May 23, 2008

Additional Information for
Application to Amend Special Use Permit File No. 72/SUP-1
Makakilo Quarry: Grace Pacific Corporation
Tax Map Keys 9-1-16: 4; 9-2-2: 6; and 9-2-3: 74 and 82

**MAKAKILO QUARRY
(Tax Map Key 9-2-3: 82)
CONDITIONAL USE PERMIT NO. 72/CUP-15
ENGINEERING REPORT AMENDMENT**

Figure 5b (part 1 of 9)

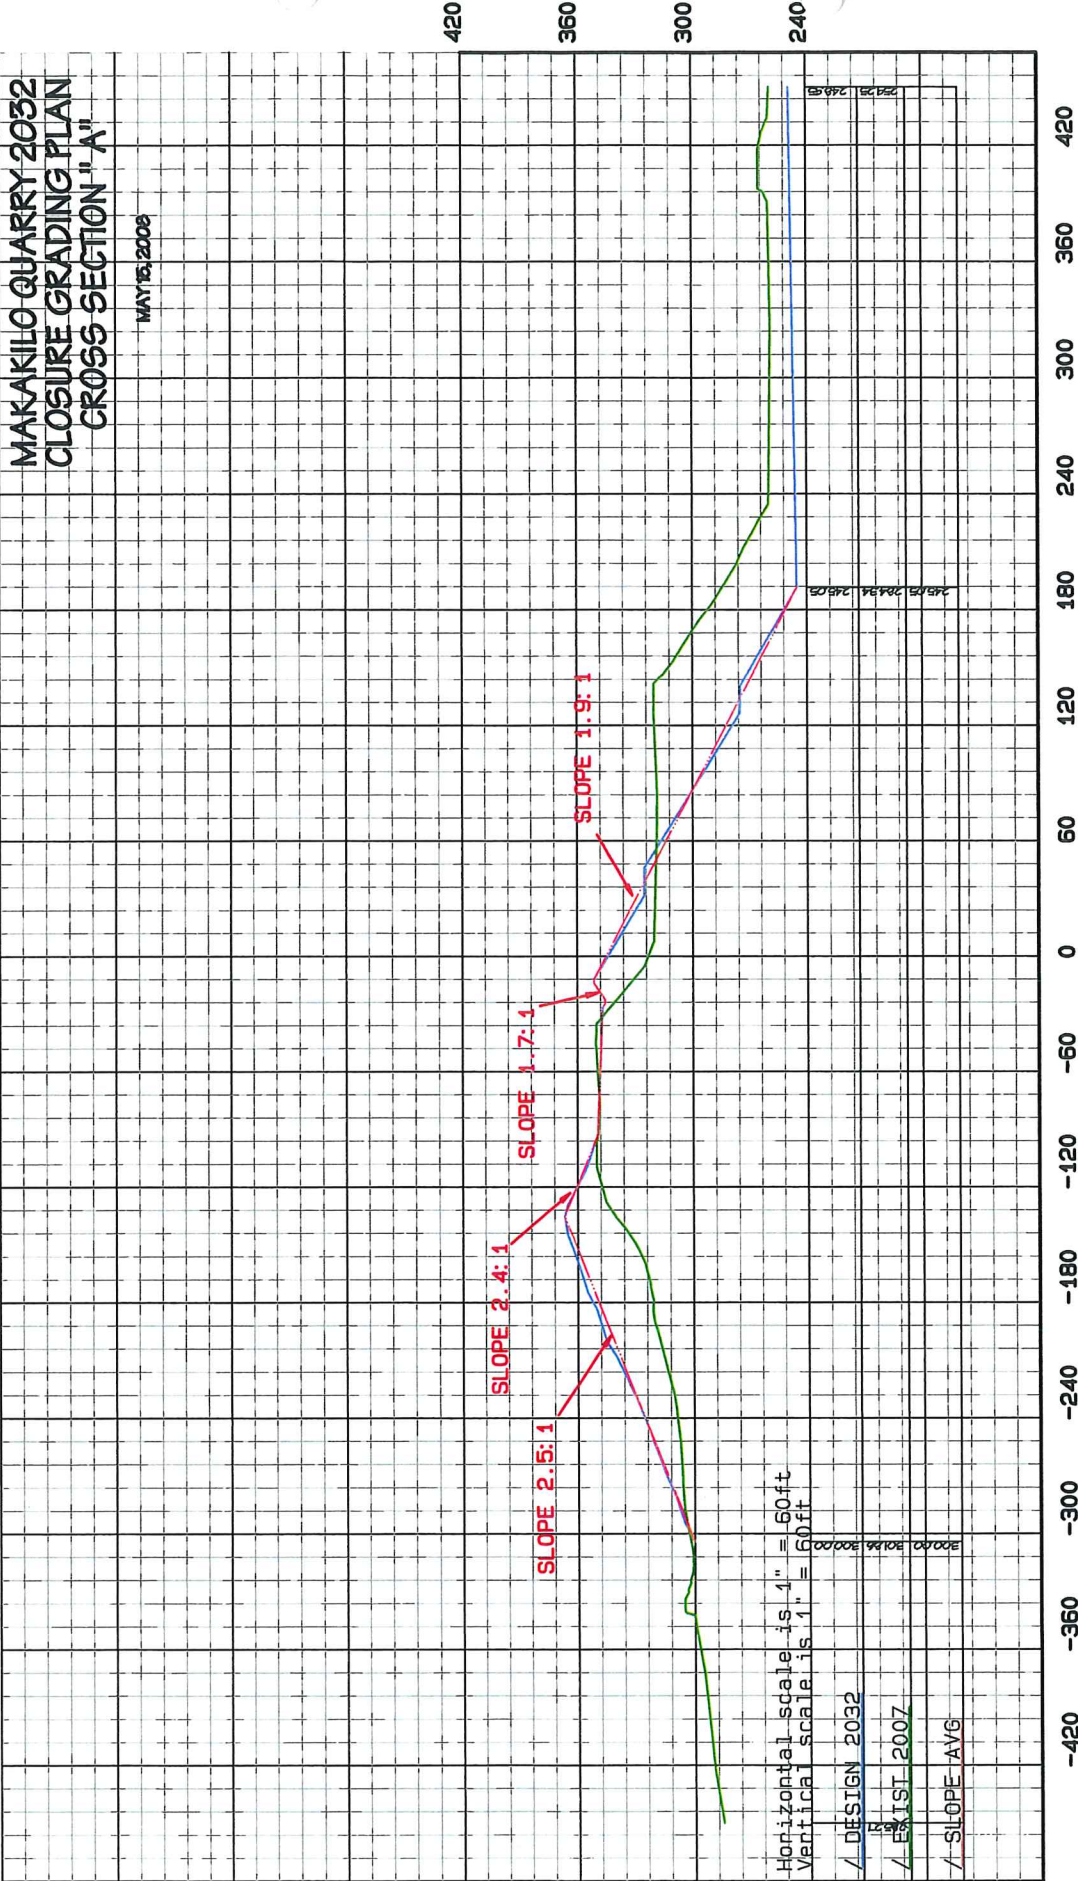
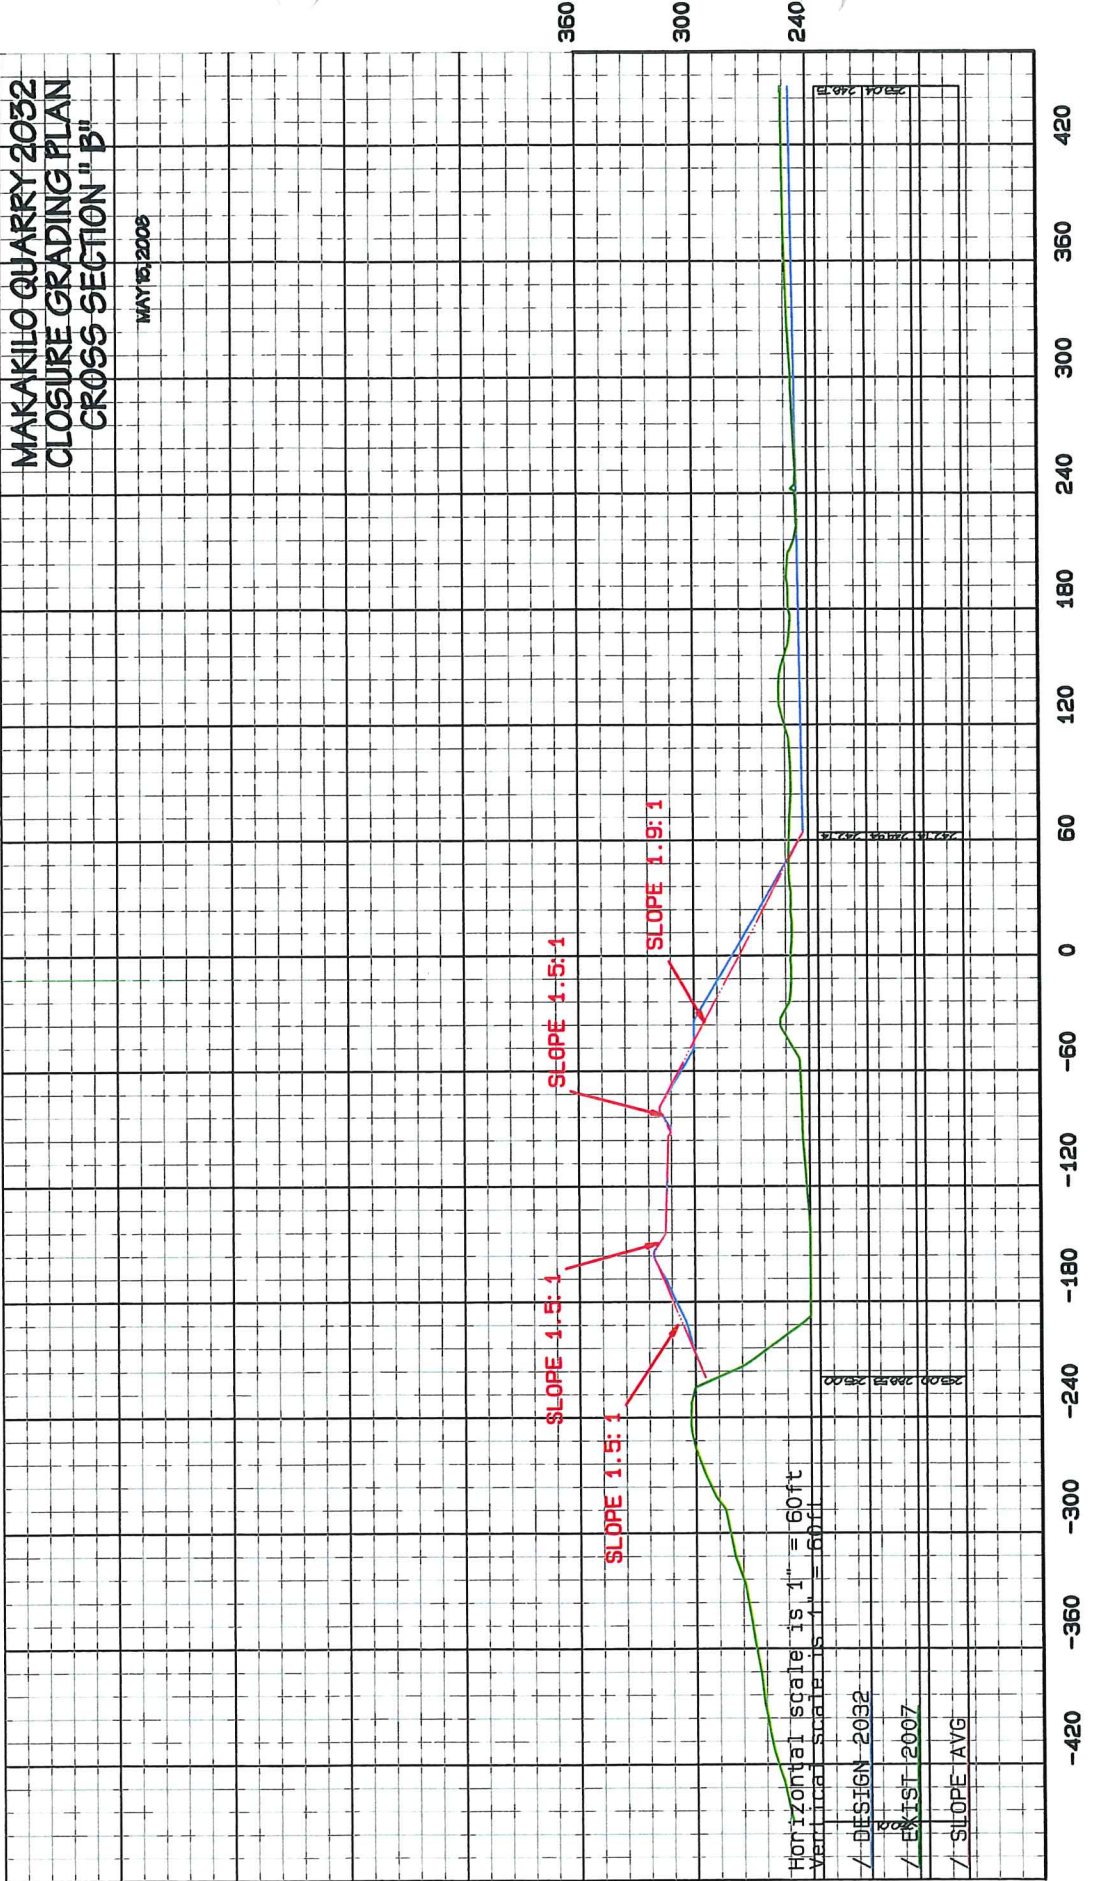
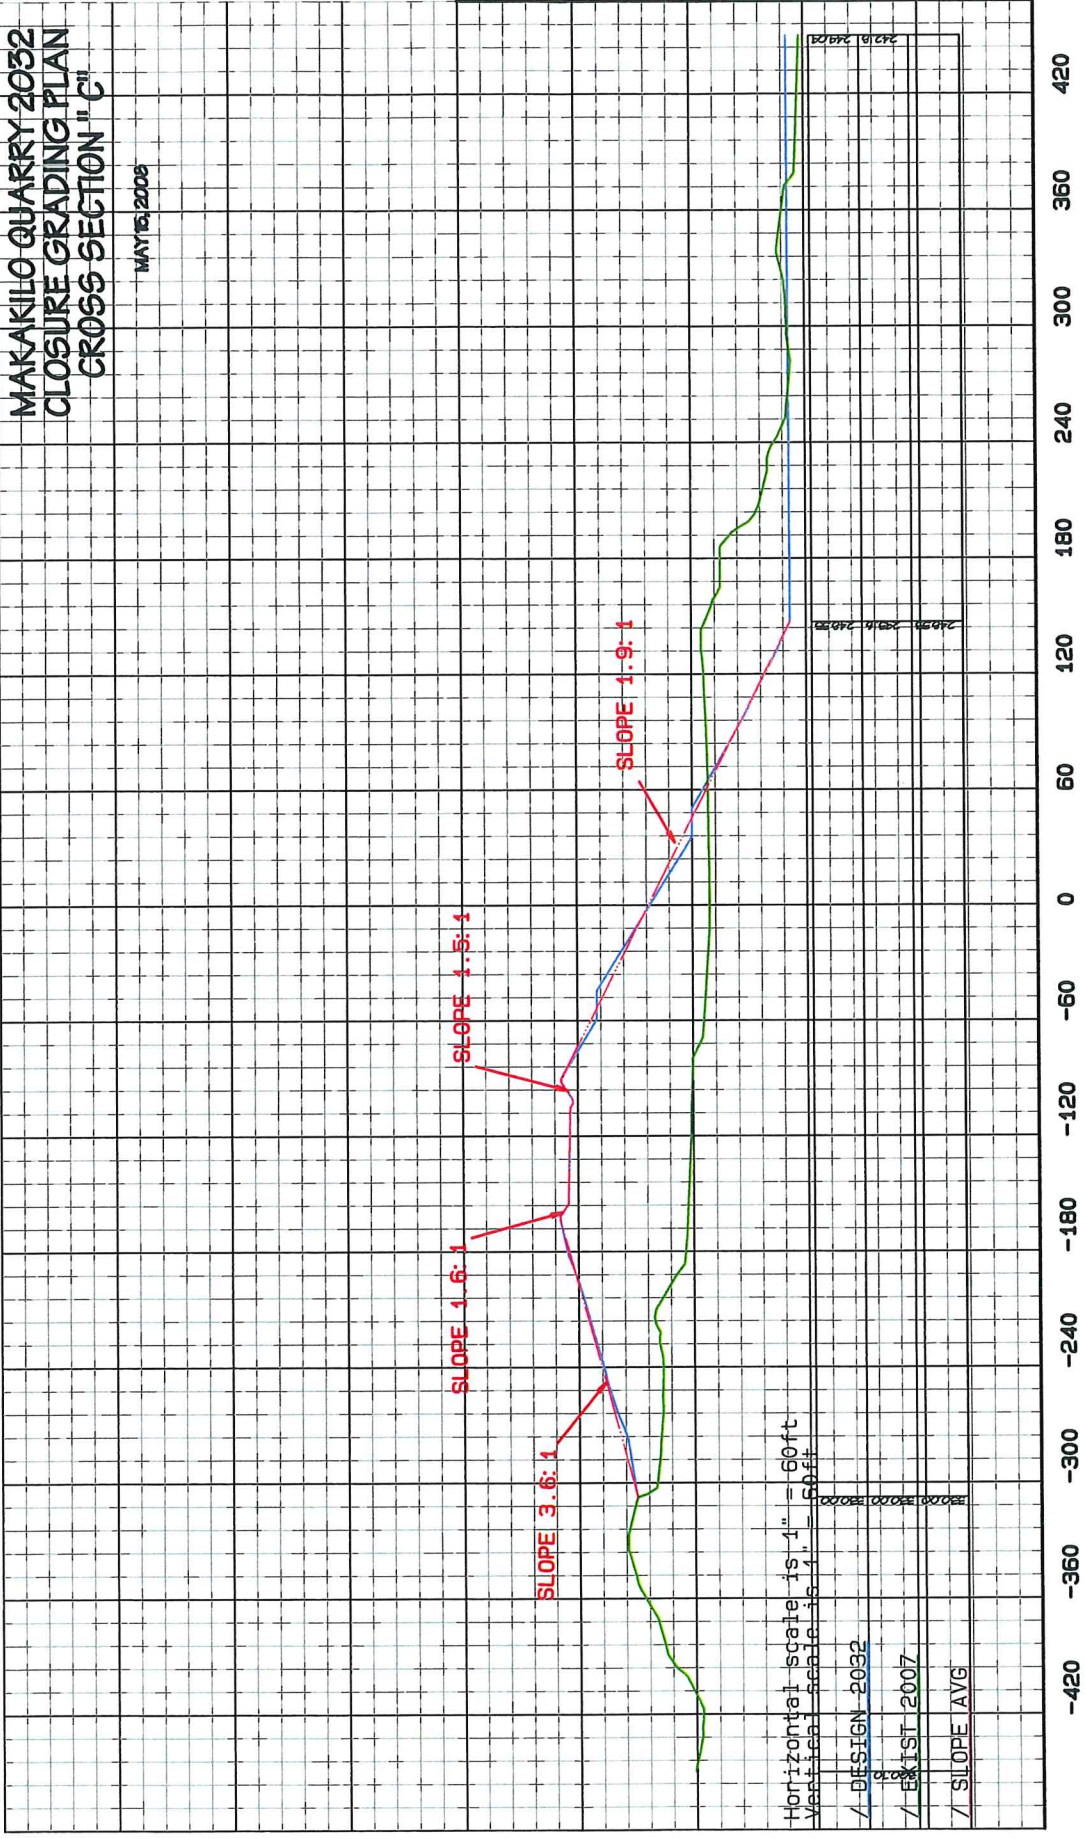
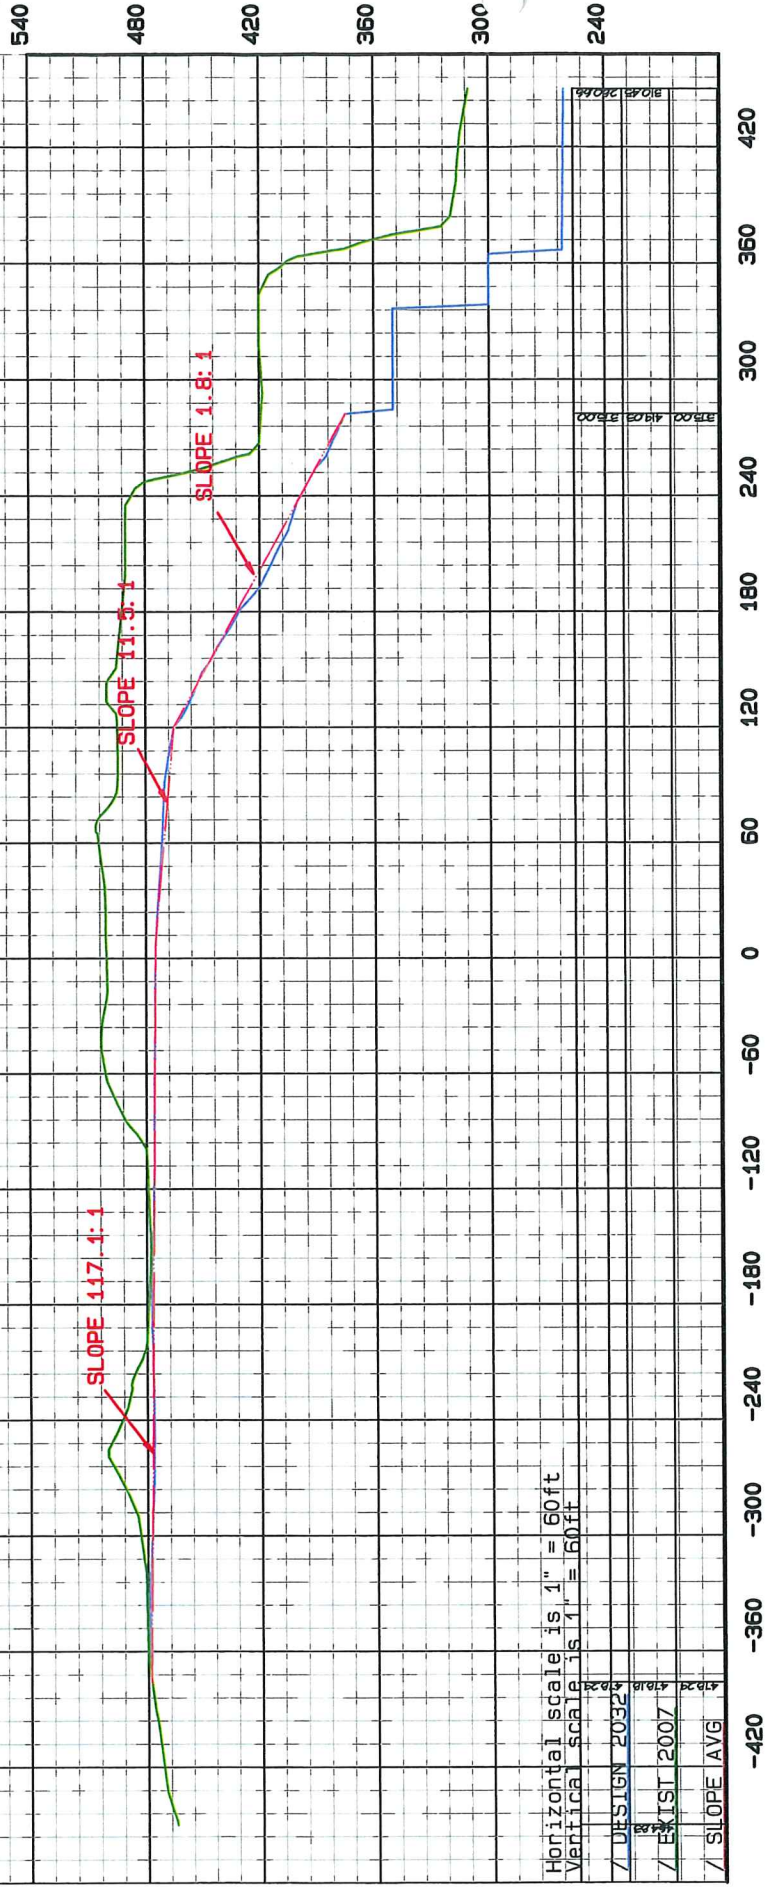
- c) Revised Figure 5a "Closure Grading Plan with Cross Section Index" in Appendix B of Exhibit K "Engineering Report Amendment" of the Application.
- d) Revised Figure 5b1 - Bb9 "Cross Sections AA through II", accompanying revised Figure 5a.
